ADOLFSON & PETERSON, INC.
AURORA, COLORADO
HEADQUARTERS
FINAL DEVELOPMENT PLAN
SITE PLAN

ADOLFSON & PETERSON, INC.
NEW OFFICE/WAREHOUSE - AURORA HEADQUARTERS
LOCATED NEAR:
6th AVENUE and VENTURA STREET

APPROVED LS PLAN IMPROVEMENTS VS PROPOSED LS IMPROVEMENTS (MINOR AMENDMENT LS PLAN JUSTIFICATION DOCUMENT)

LANDSCAPE PLAN

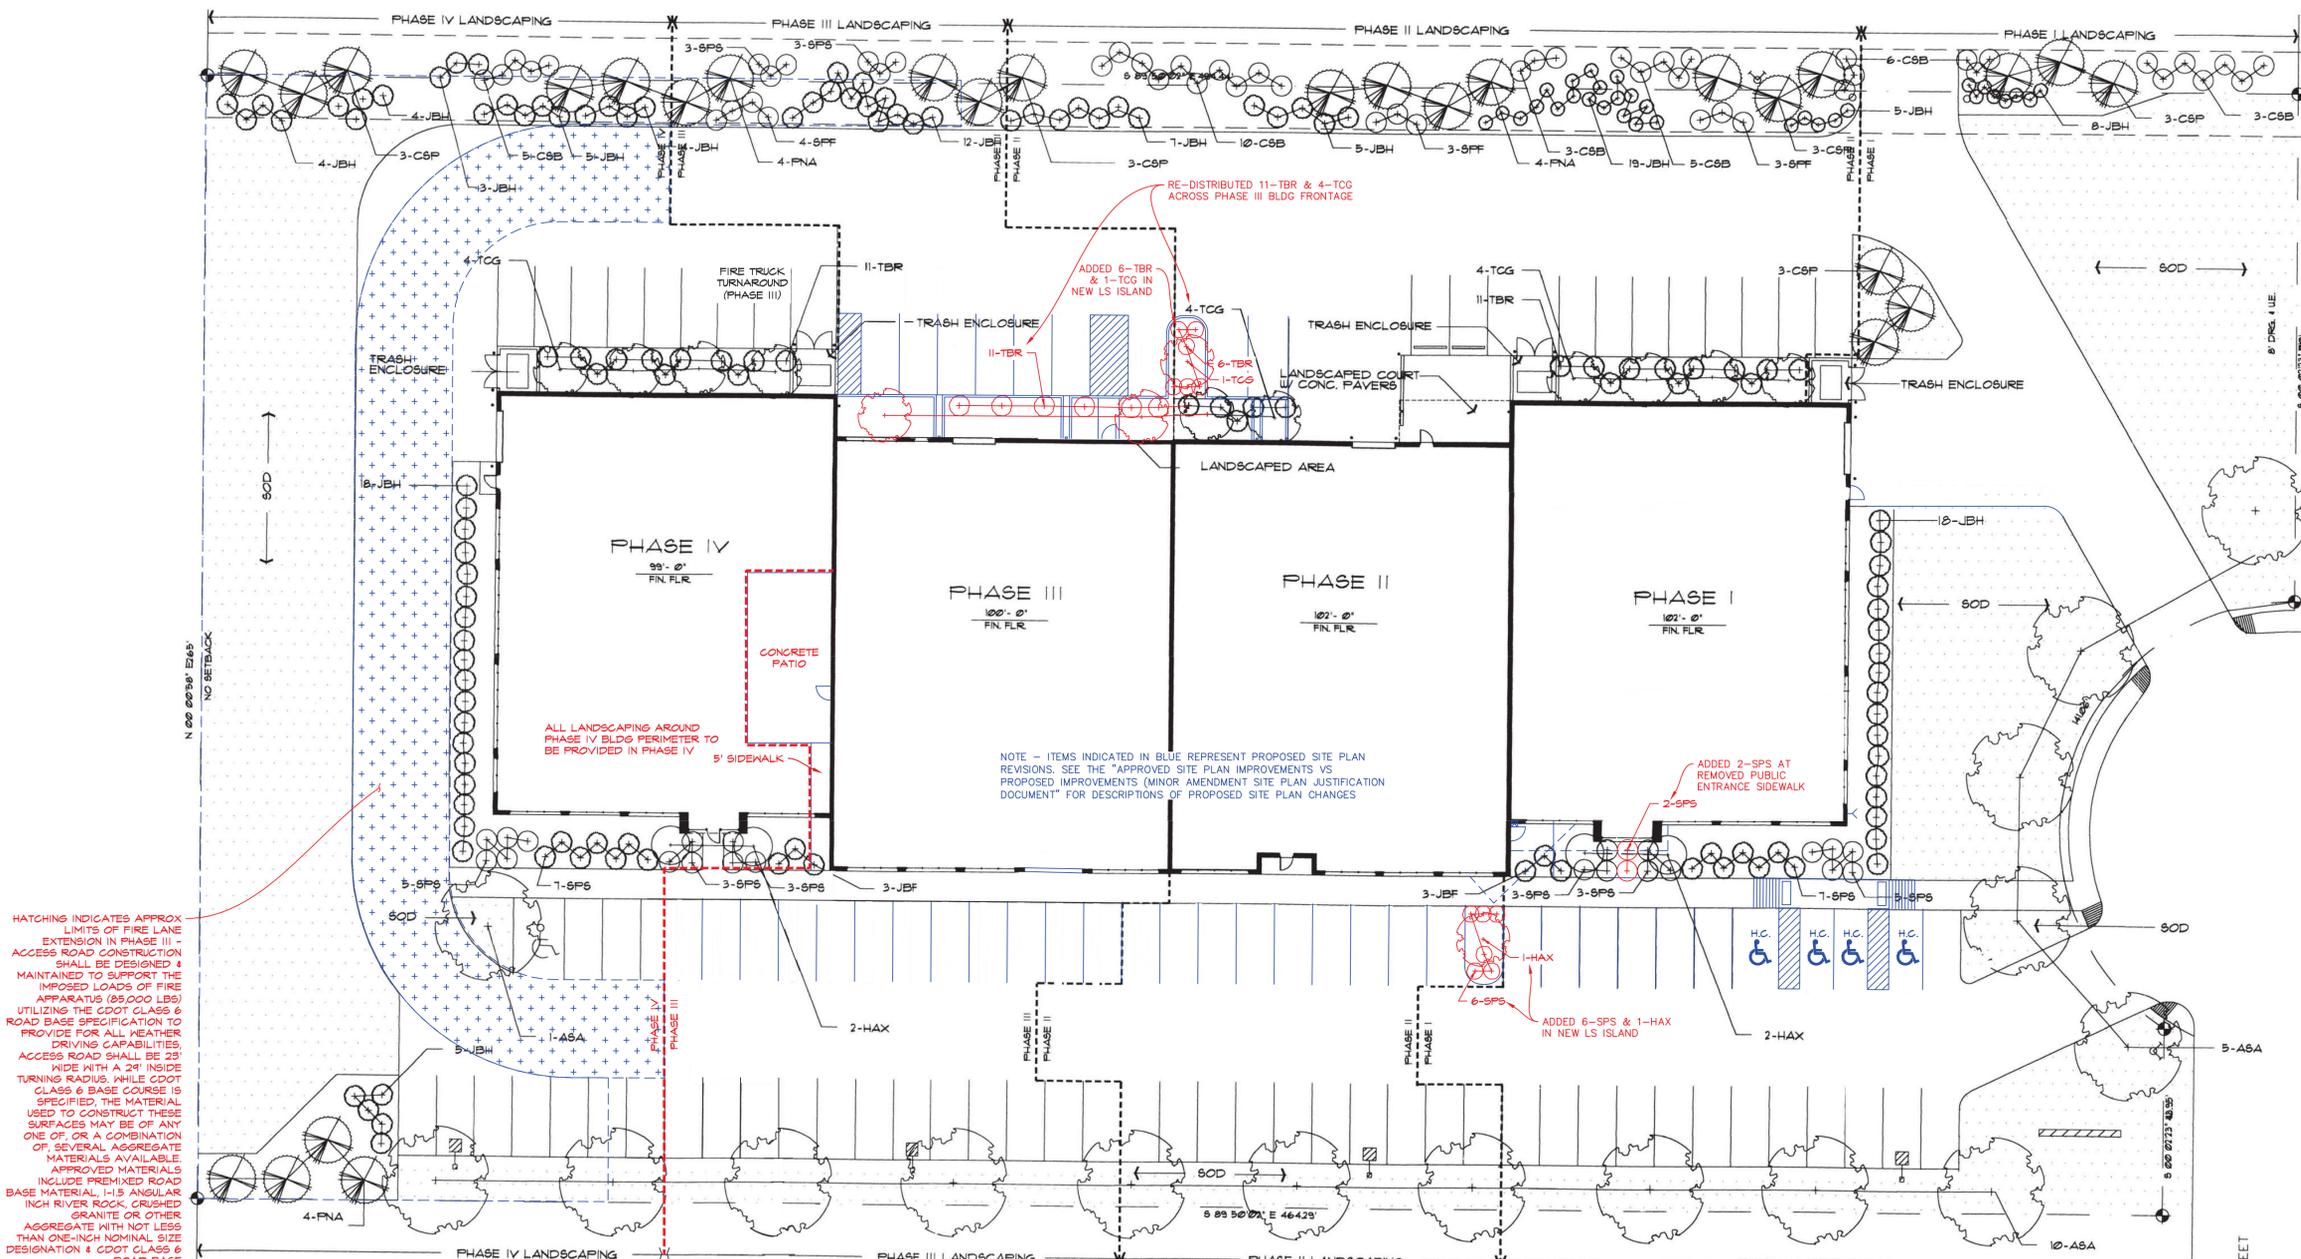
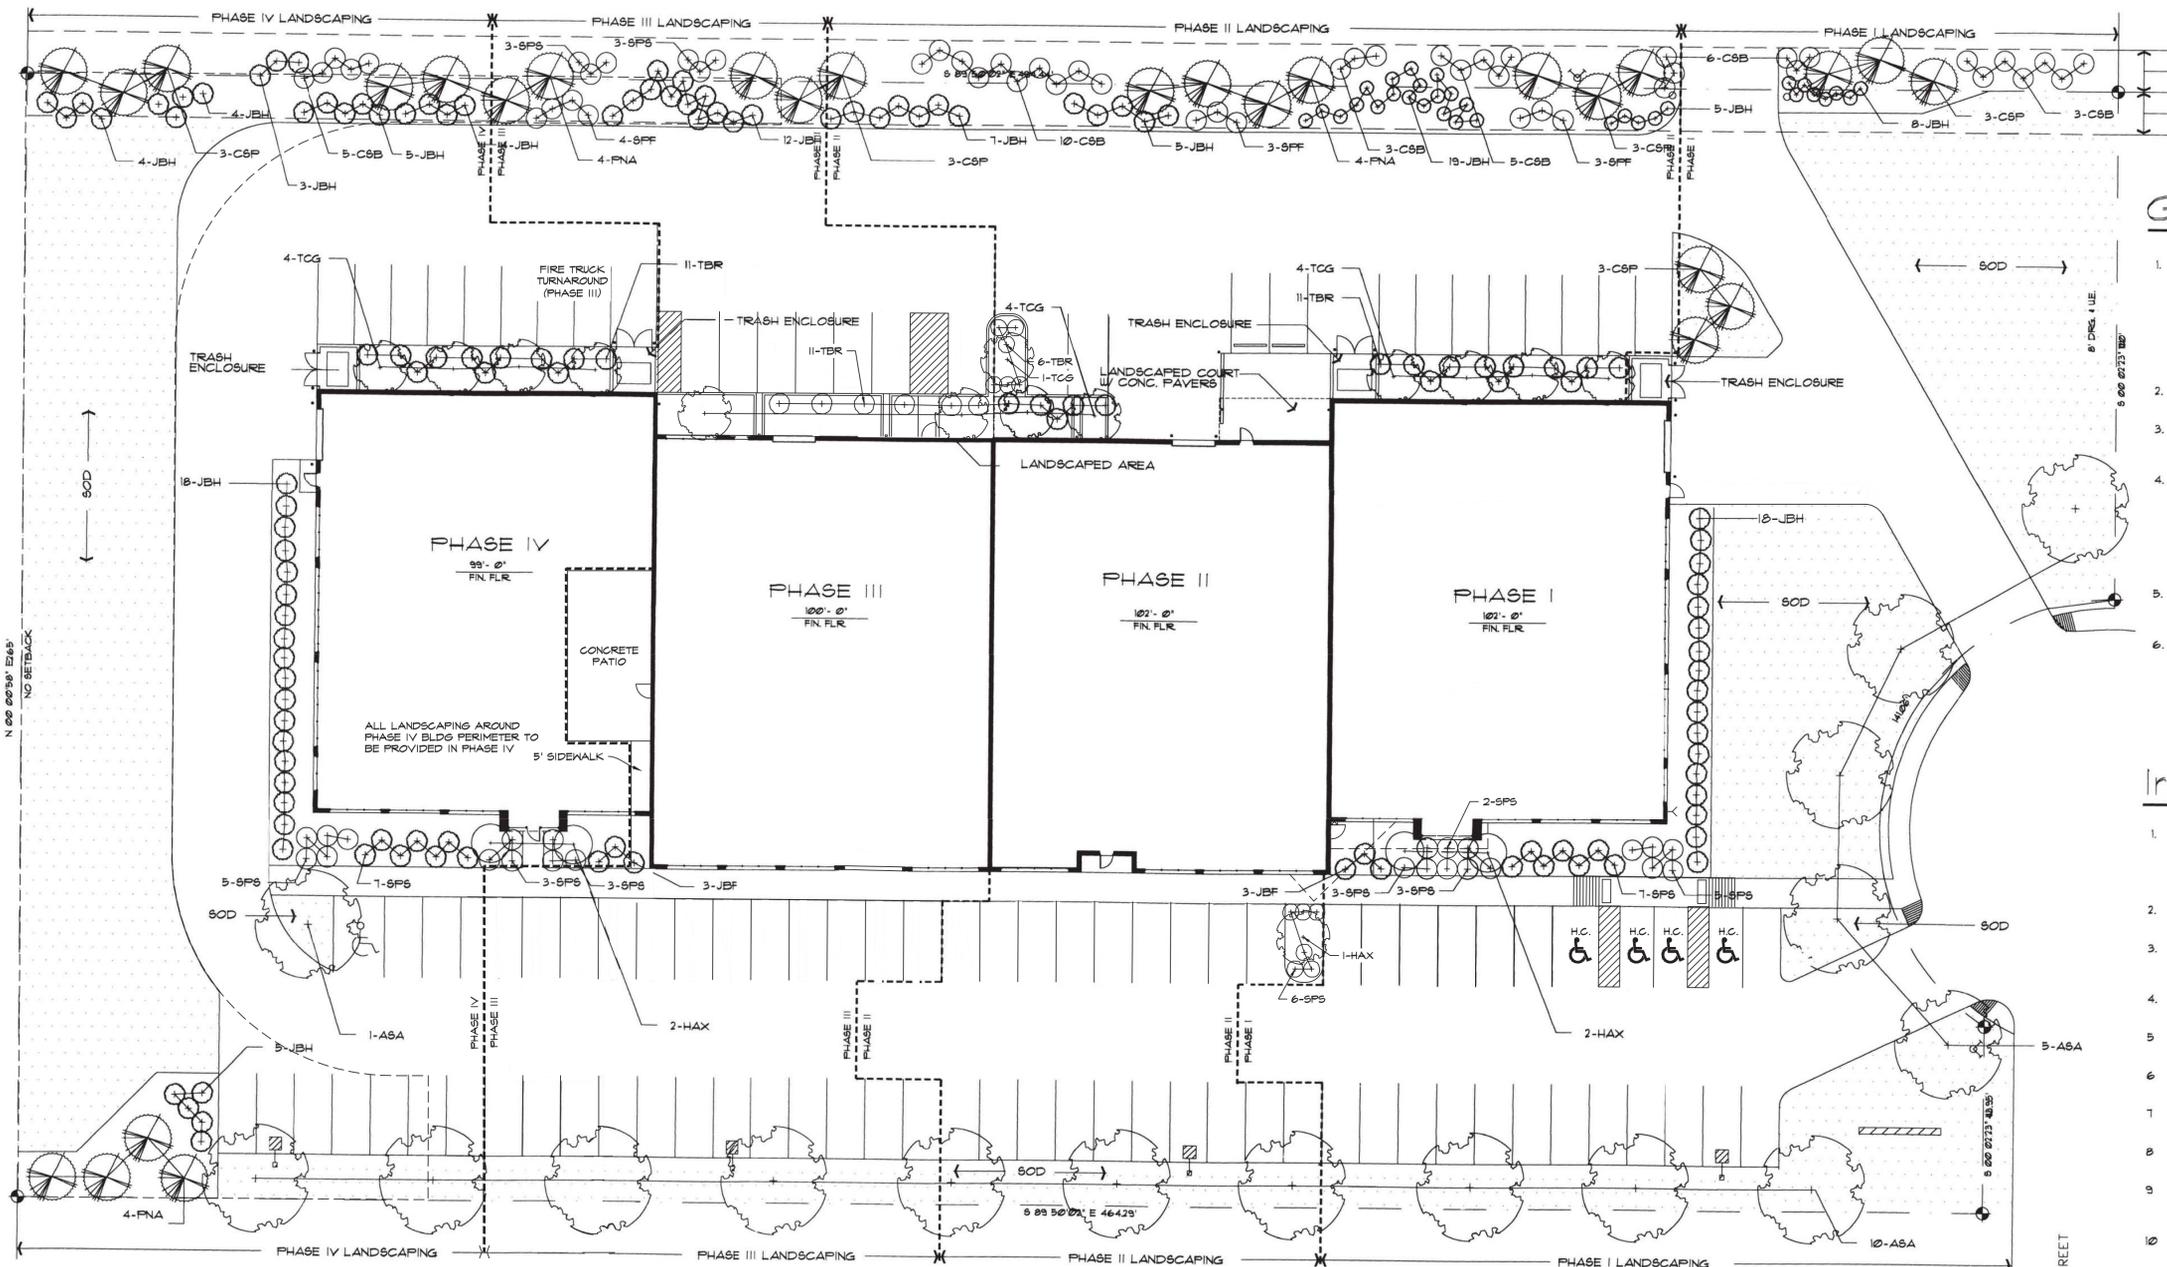
- 1. ADD LANDSCAPING (2-SPS) AT REMOVED BLDG ENTRANCE SIDEWALK
- 2. ADD 6-SPS & 1-HAX AT NEW LANDSCAPED ISLAND
- 3. REVISED PHASE III LIMITS TO INCLUDE 5' SIDEWALK, CONCRETE PATIO WEST OF PHASE III BLDG & PAVING/PARKING WHICH EXISTS SOUTH OF PHASE II BLDG
- 4. RE-DISTRIBUTE 11-TBR & 4-TCG ACROSS NORTH SIDE OF PHASE III BLDG FRONTAGE; ADD 6-TBR & 1-TCG AT NEW LANDSCAPE ISLAND

BUILDING PERIMETER & LANDSCAPE ISLAND ADDITIONS
